PLANNING COMMISSION

Meeting Agenda Monday, April 10, 2017 7:00 PM

RE: Trail Crossing Apartments, Review and Final Approval of Revised Site Plan Design

(DR 17-02/VAR 17-01)

SITE & PROJECT DATA:

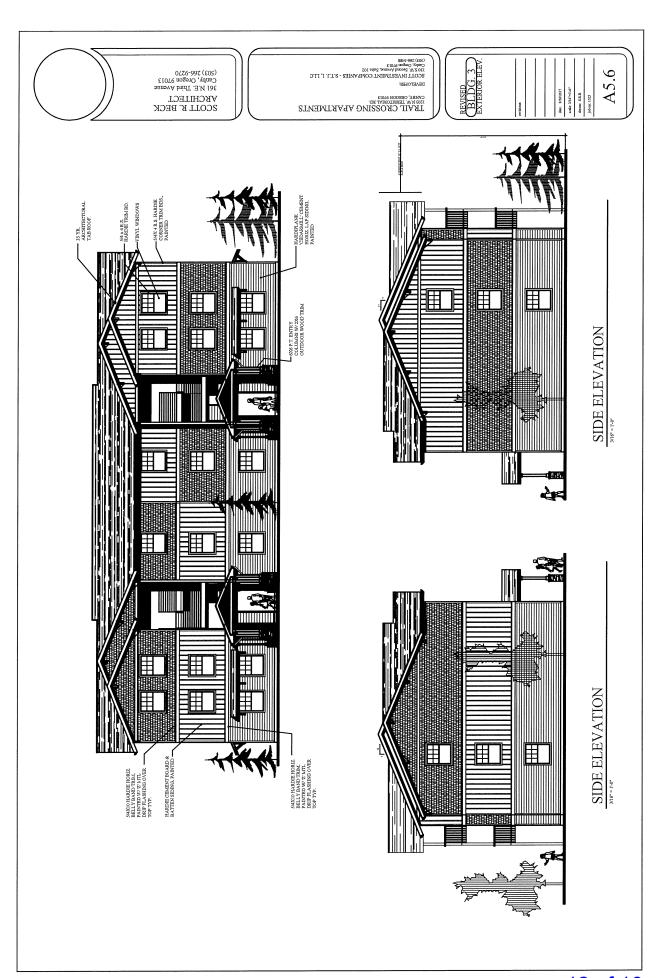
- Removal of two of the originally proposed parking spaces lying within 35' of the back of sidewalk at the driveway,
- Changing 6 two-bedroom units to 6 one-bedroom units to decrease the required parking standard by six spaces.
- Indicated support of a parking variance of up to 3 parking spaces below the standard ordinance requirement of 109 based on the required revised mix of unit types.
- Supported and granted the requested variance of the landscape islands within the parking banks as proposed to provide a degree of flexibility in meeting parking requirements in recognition that the overall parking lot area landscaping area exceeded minimum requirements by approximately 34%.
- Required that a final reconfigured Site Plan indicating the final unit mix and conformance with the above parking parameters be brought back for final layout approval for the April 10, 2017 regular meeting.

- 1. The revised project design includes a changed unit mix: (6) one bedroom, (42) two bedroom and (10) three bedroom units.
- 2. The footprint of Building 3 has been changed to accommodate the one bedroom units and the additional one bedroom handicap unit.

- 3. Two (2) parking stalls have been eliminated at the Territorial Rd. vehicle entrance. This includes (1) stall each side of the entry driveway as recommended by the Traffic Study.

- 4. The parking stalls on the immediate west face of Buildings 1 and the Rec. Building have been changed to 8'-6" in width. This yields (1) additional parking stall to the project.

- 5. One (1) parking stall in front of Buildling 3 has been converted to a handicap stall so that the one and two bedroom handicap units each have access to a handicap stalls near their entries.

- 6. The change in unit mix and modifications to the parking proposed result in a request for parking variance of (3) stalls.
